29th Floor - M-529.00: Change Areas, Before and After

Snowflake Fitout - 7 Times Square, Floors 29-31 | COP-SF-05 Bulletin 3 Revision

29th Floor - M-529.00: Scope of Work and Cost Breakdown

29-1 North supply main - reroute through existing beam cuts \$13,875

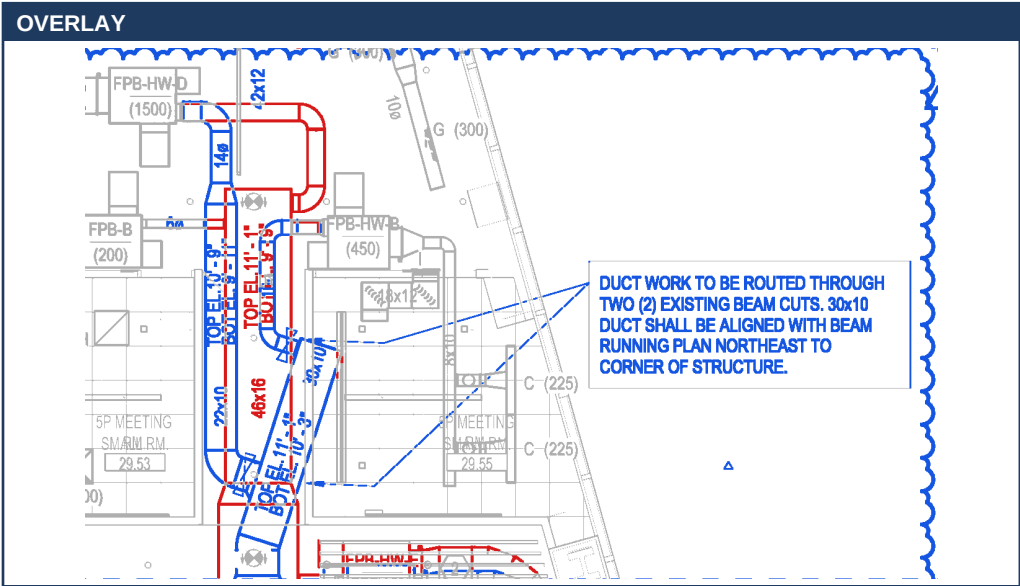
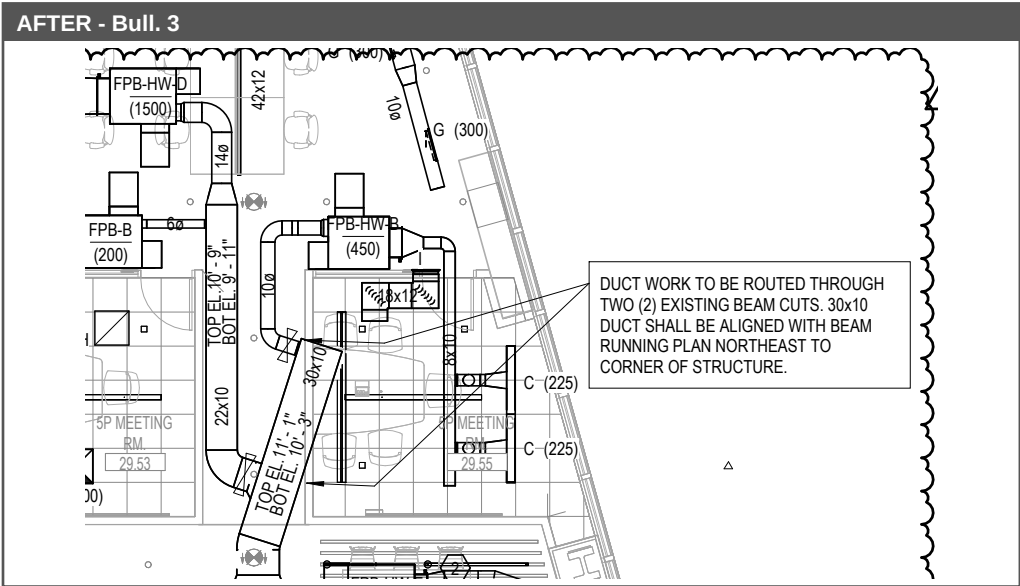
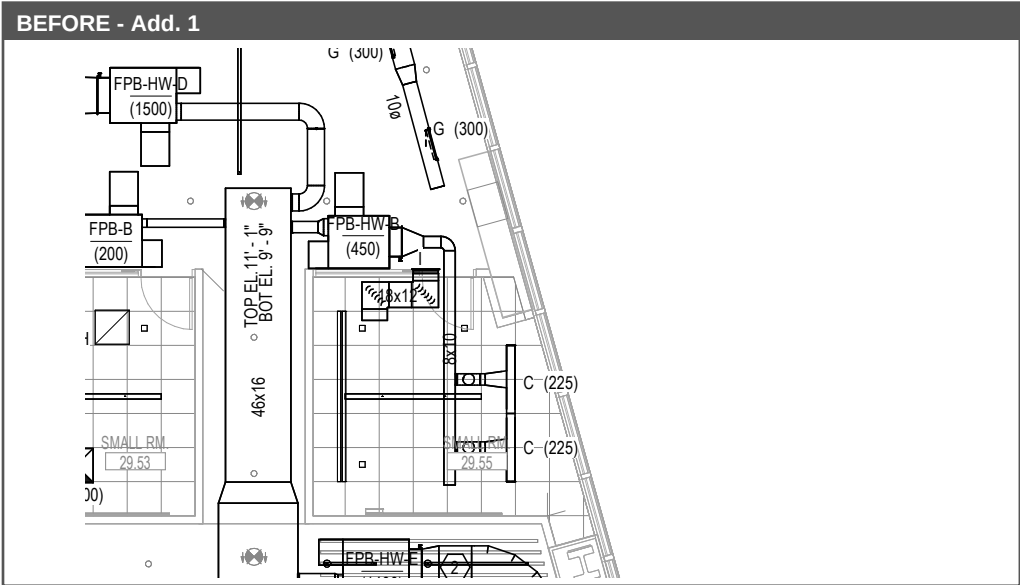
Area	Scope of work	Disconnect / removal	Material	Install labor	Total
29-1	North supply main - reroute through existing beam cuts Before: 46x16 supply main (approx. 20 LF, bottom el. 9'-9") with branch connections to FPB-HW-D (1500), FPB-HW-B (450) and FPB-B (200). After: Main rerouted as 22x10 and 30x10 through (2) existing beam cuts, 30x10 aligned with the beam running plan northeast. New 14ø branch to FPB-HW-D, 10ø to FPB-HW-B and 6ø to FPB-B. Work: Disconnect and remove installed 46x16 section and branch connections. Fabricate and install 22x10 / 30x10 duct and round branches with insulation.	12 MH \$1,500	\$4,875	60 MH \$7,500	\$13,875
29-2	Supply main resized 56x16 to 42x12 Before: 56x16 supply main, approx. 44 LF, top el. 11'-1" / bottom el. 9'-9", Break Rm 29.57 to P.E. After: Main resized to 42x12 on the same route, top el. 11'-1" / bottom el. 10'-1". Work: Disconnect and remove installed 56x16 main. Fabricate and install 42x12 main with insulation.	16 MH \$2,000	\$4,975	50 MH \$6,250	\$13,225

29-3 FPB-HW-E (1400) relocation and discharge reroute \$1,500

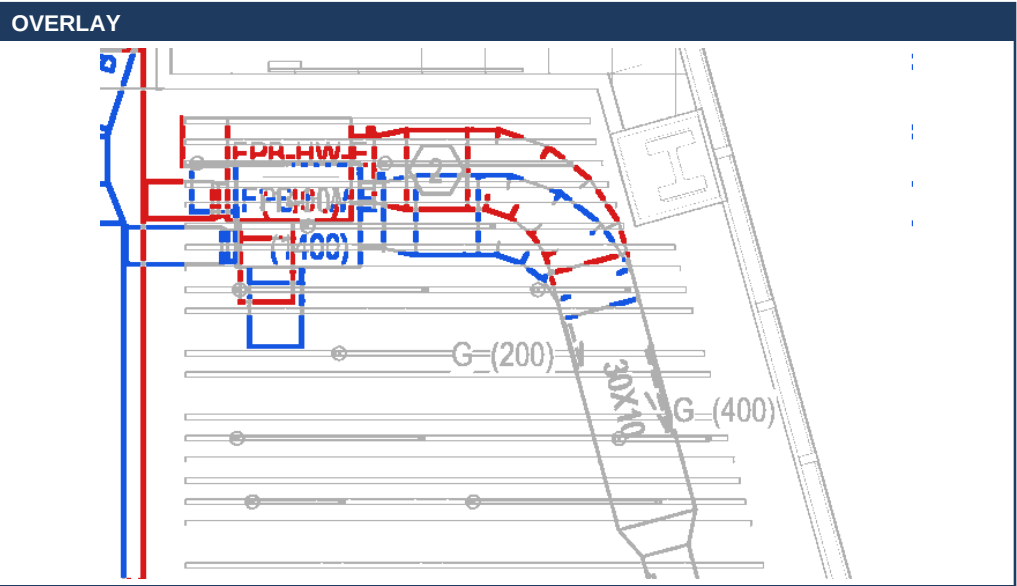
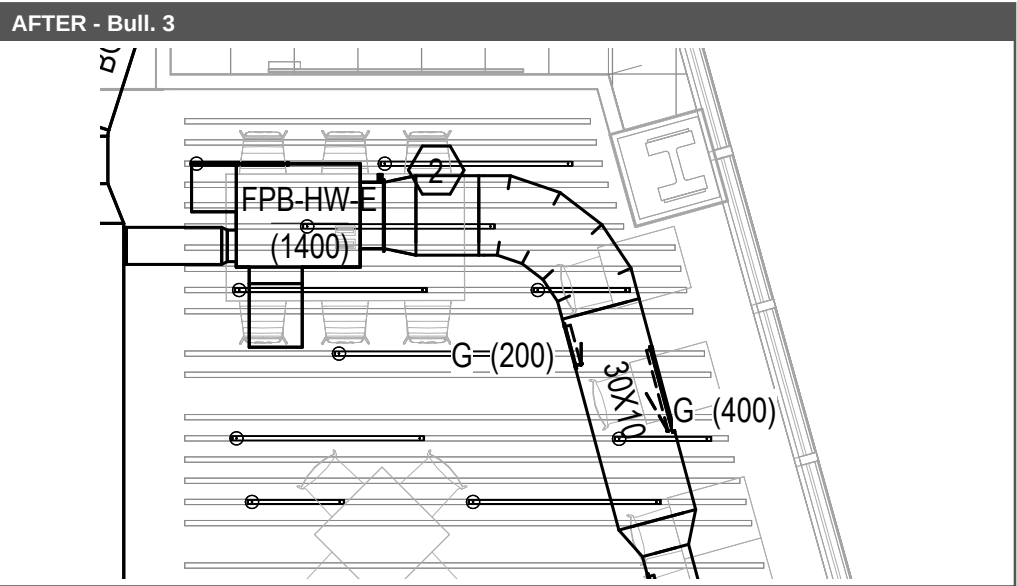
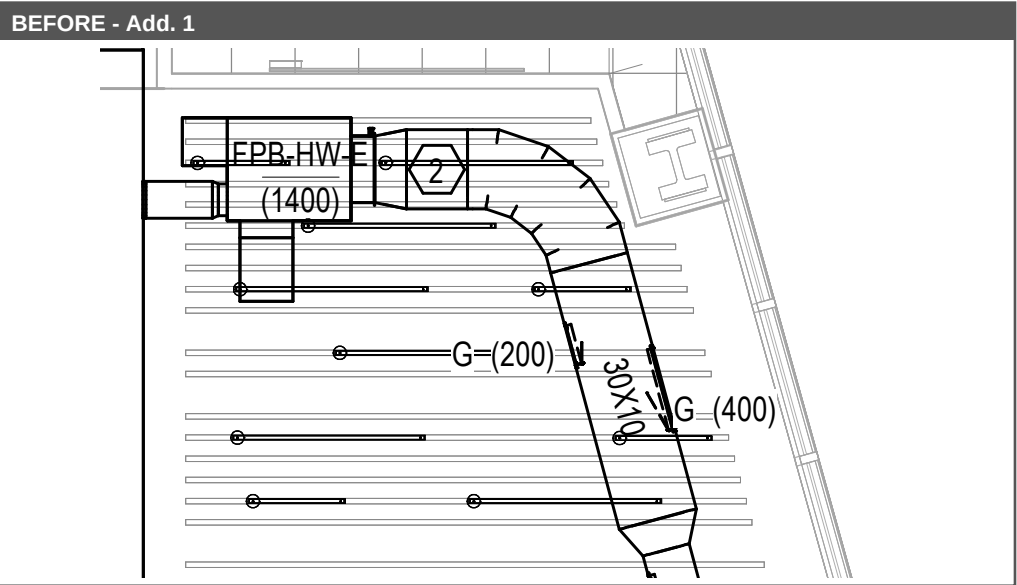
29-3	FPB-HW-E (1400) relocation and discharge reroute Before: FPB-HW-E (1400) with inlet and 30x10 discharge to the G(400) / G(200) linear diffusers along the northeast wall. After: FPB-HW-E relocated; inlet connection and 30x10 discharge elbow rerouted. Work: Disconnect inlet and discharge, relocate and rehang FPB-HW-E, fabricate and install new inlet and 30x10 discharge fittings, reconnect.	2 MH \$250	\$500	6 MH \$750	\$1,500
	Shop drawings for revised design				\$1,000
	29th floor total (30 MH disconnect, 116 MH install)	\$3,750	\$10,350	\$14,500	\$29,600

30-1 IT Build Rm 30.23 / F&B Storage 30.14 / west dining \$10,300

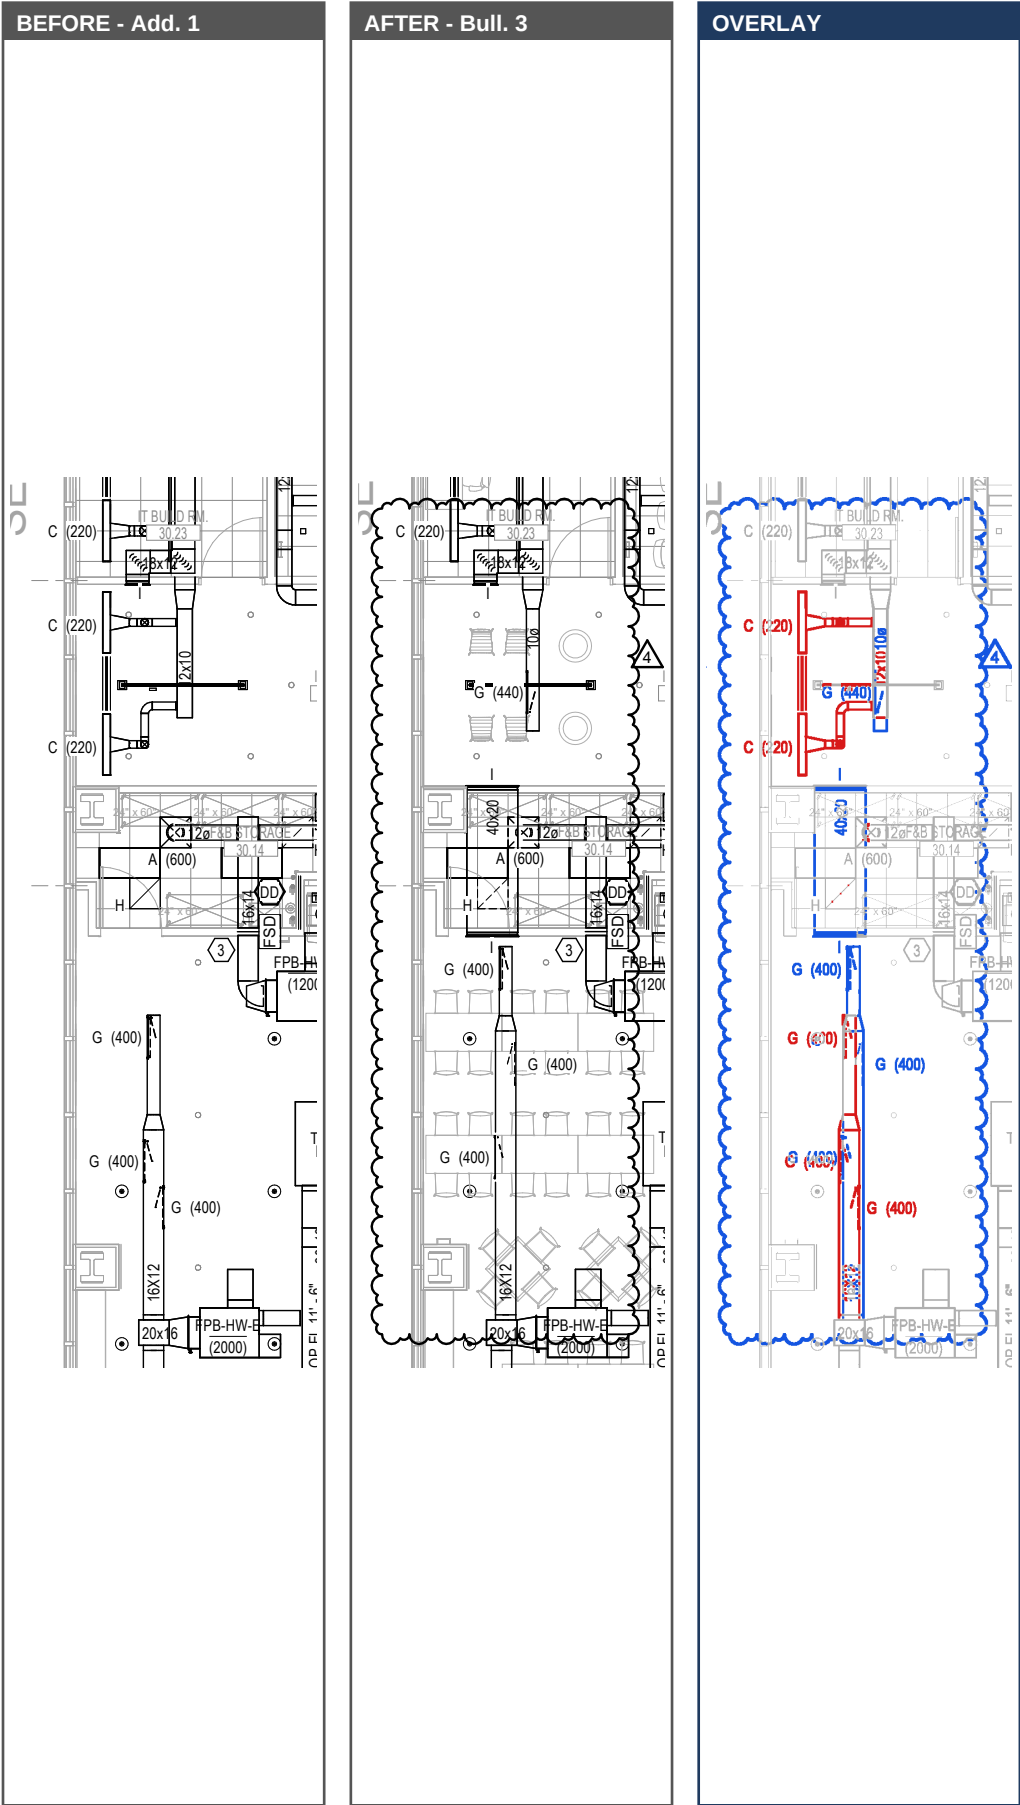
Area	Scope of work	Disconnect / removal	Material	Install labor	Total
30-1	IT Build Rm 30.23 / F&B Storage 30.14 / west dining Before: 12x10 branch with (2) C(220) ceiling diffusers; G(400) linear diffuser run on 16x12 branch. After: 12x10 branch and (2) C(220) deleted, replaced with 10ø branch to (1) new G(440) linear diffuser. New 40x20 transfer duct at F&B Storage 30.14. G(400) diffusers relocated along the 16x12 branch. Work: Disconnect and remove 12x10 branch and (2) C(220). Install 10ø branch, 40x20 transfer duct, rework 16x12 branch. F&I G(440). F/I (2) 40x20 wall transfer grilles.	8 MH \$1,000	\$4,300	40 MH \$5,000	\$10,300
30-2	Lounge 30.02 - new transfer ducts Before: No transfer ducts at Lounge 30.02 walls. After: (2) new 48x24 transfer ducts with 1" AL. Work: Fabricate and install (2) 48x24 lined transfer ducts and (2) 48x24 transfer return grilles.	-	\$2,400	20 MH \$2,500	\$4,900

30-3 Meeting Rms 30.04 / 30.05, Storage 30.09, Vestibule 30.07 \$3,950

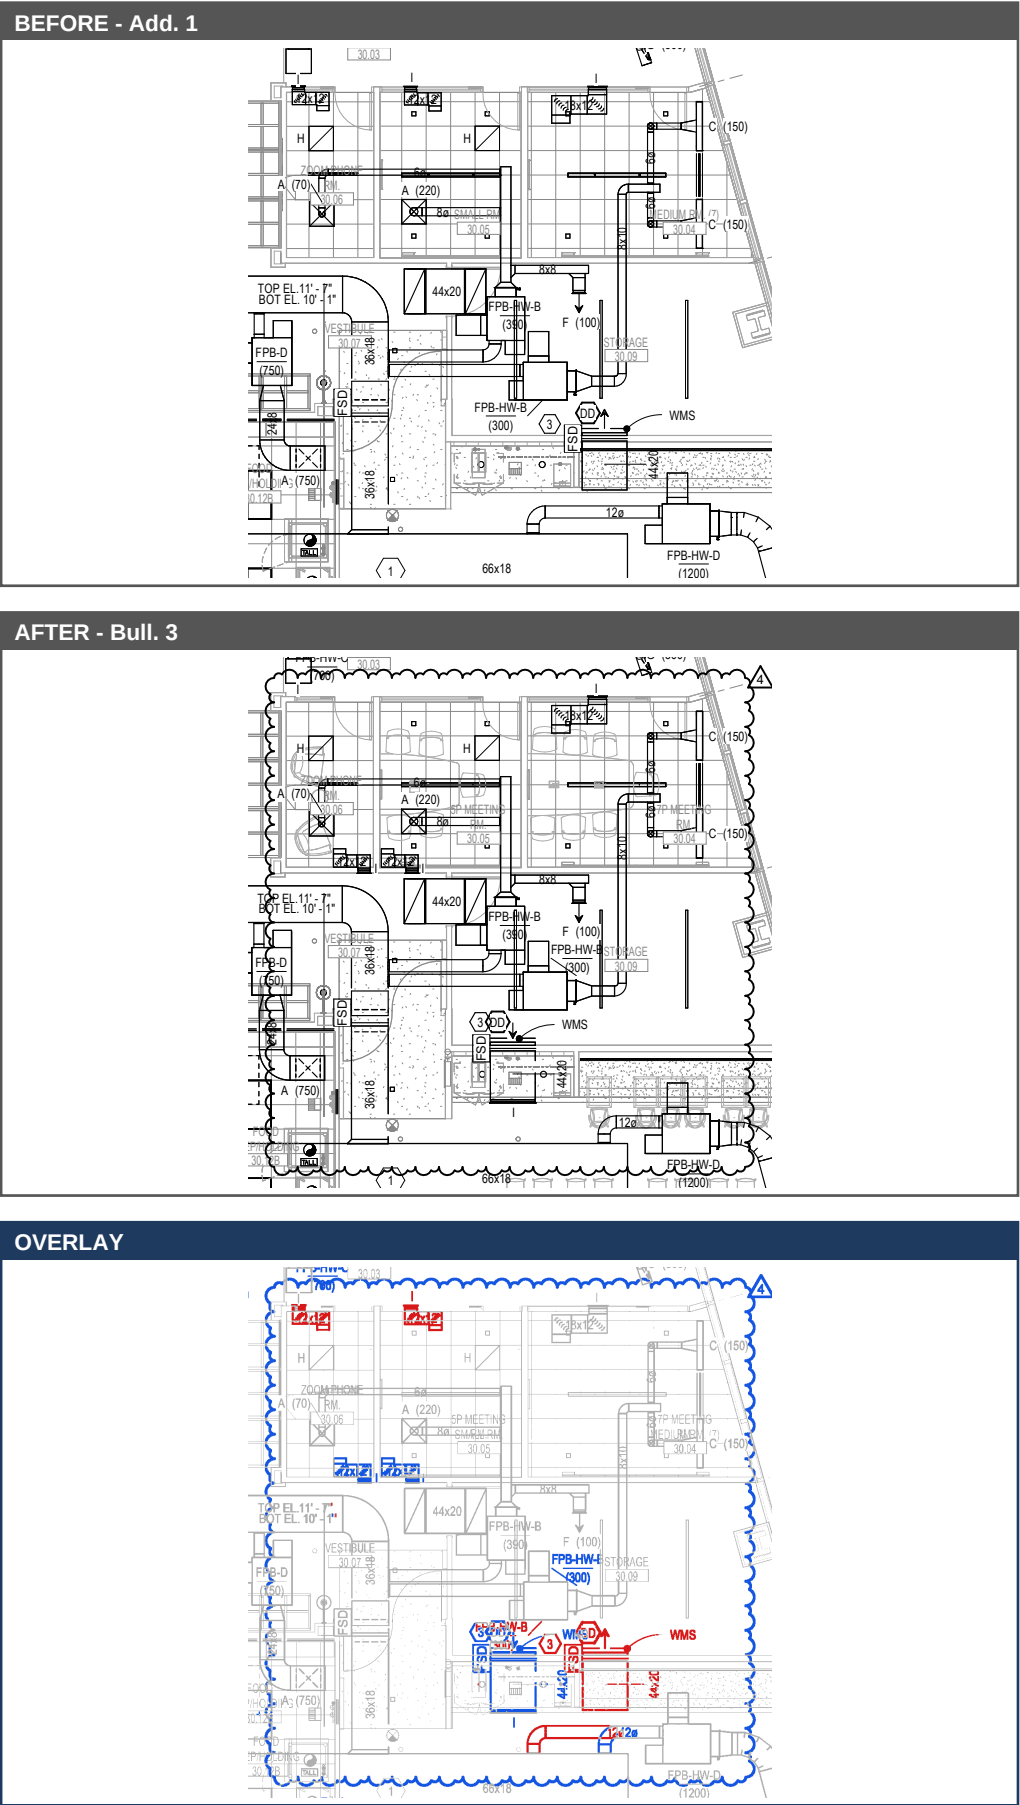
30-3	Meeting Rms 30.04 / 30.05, Storage 30.09, Vestibule 30.07 Before: 44x20 transfer duct; (2) 12x12 grilles; 12ø branch to FPB-HW-D (1200). After: (2) 12x12 grilles relocated to 5P / 7P Meeting; 12ø branch rerouted. Work: Disconnect and remove affected duct, FSD, fittings. Install 44x20 duct, FSD with angles, and 12ø branch at new locations.	12 MH \$1,500	\$200	18 MH \$2,250	\$3,950
	Shop drawings for revised design				\$1,000
	30th floor total (20 MH disconnect, 78 MH install)	\$2,500	\$6,900	\$9,750	\$20,150
